CERTIFICATE OF THE SECRETARY OF ENERGY AND ENVIRONMENTAL AFFAIRS
ON THE
THIRD NOTICE OF PROJECT CHANGE

PROJECT NAME : Kendall Square Urban Redevelopment Plan (KSURP) -
Amendment #11
PROJECT MUNICIPALITY : Cambridge (Kendall Square)
PROJECT WATERSHED : Charles River
EEA NUMBER : 1891
PROJECT PROPONENT : Cambridge Redevelopment Authority
DATE NOTICED IN MONITOR : September 22, 2021

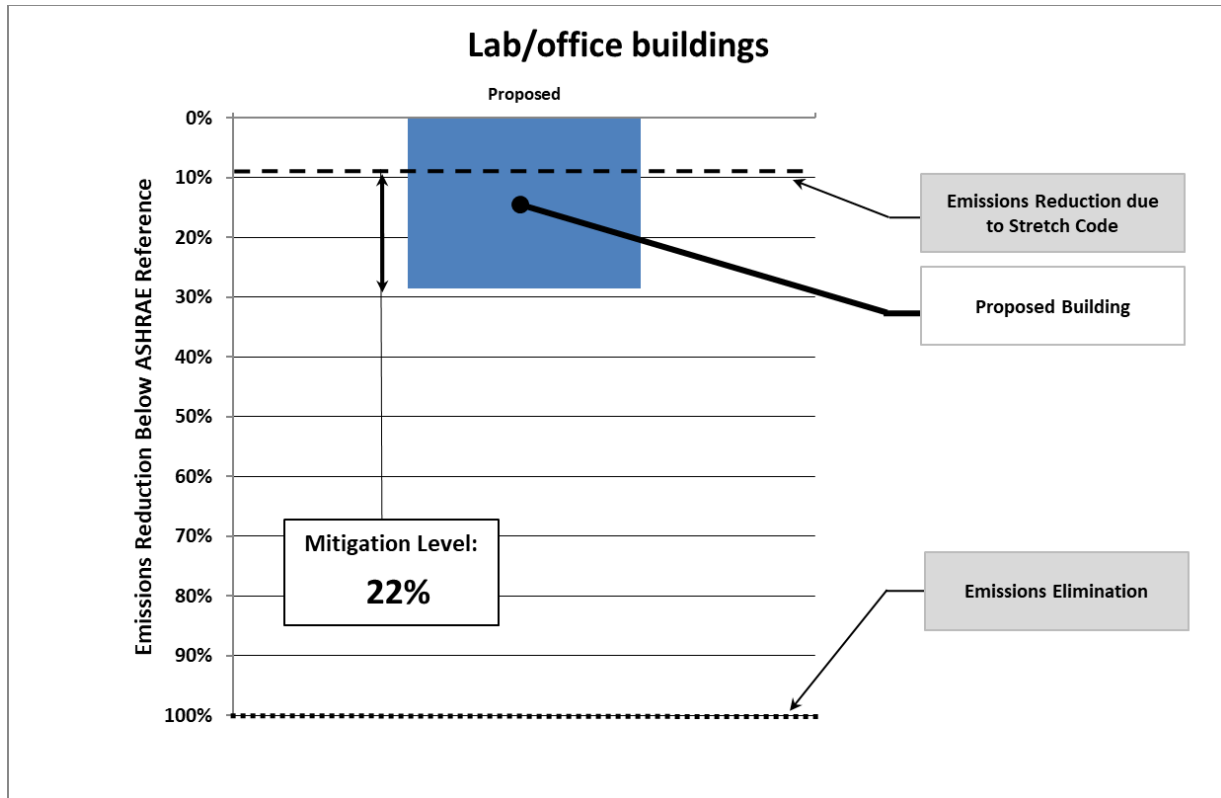
We've reviewed the Notice of Project Change (NPC) for the proposed project. The project includes two lab/office building (973,000-sf, total) and a 420,000-sf residential building (560 units).

The project was very responsive to recommendations in our ENF, including evaluating and committing to hybrid electrification in the lab/office, full electrification of the residential, and other significant emissions reduction measures. In addition, the project is making significant progress to reduce gas emissions, including an 89% reduction in gas emissions in the lab/office and elimination of gas emissions in the residential building.

Mitigation level – Residential

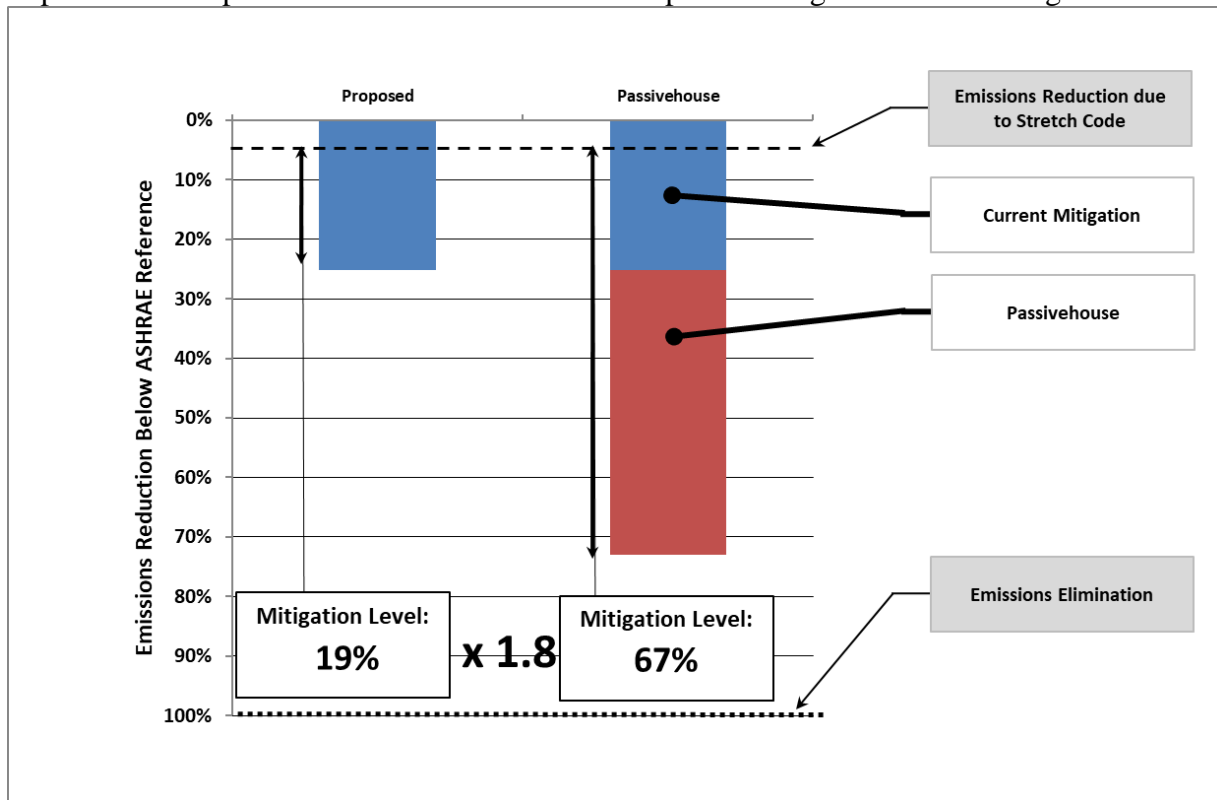
Mitigation Level for the residential building is 19%. This ML is largely achieved through improved envelope and full electrification of both space heating and water heating.

ML could be improved by x1.8 to 67% with Passivehouse design. Passivehouse would could also enable the project to access \$1.12M in MassSave incentives.

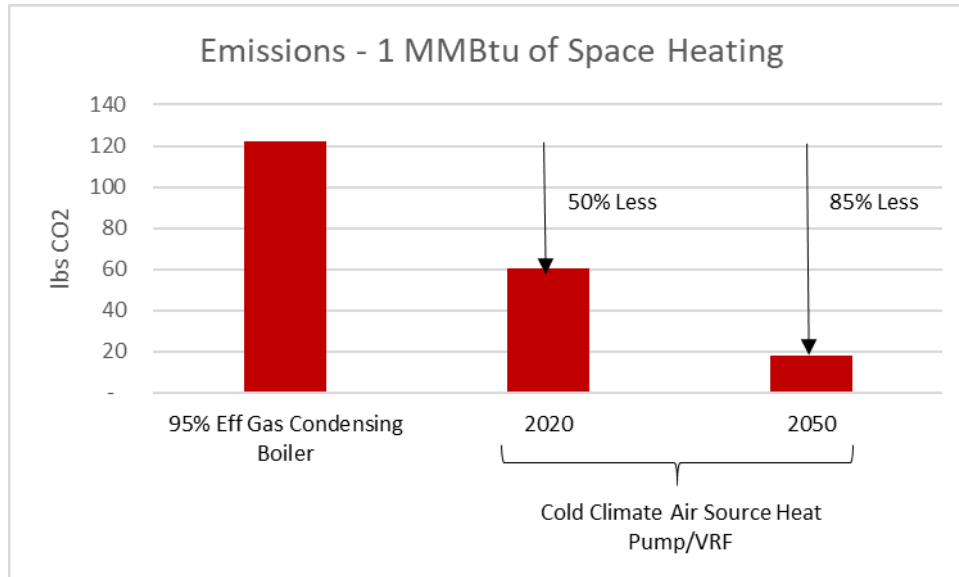
The lab/office building did not appear to evaluate a common current heating/cooling energy recovery strategy for these building types: heat recovery chillers (HRCs). We recommend the project evaluate heat recovery chillers for these buildings.
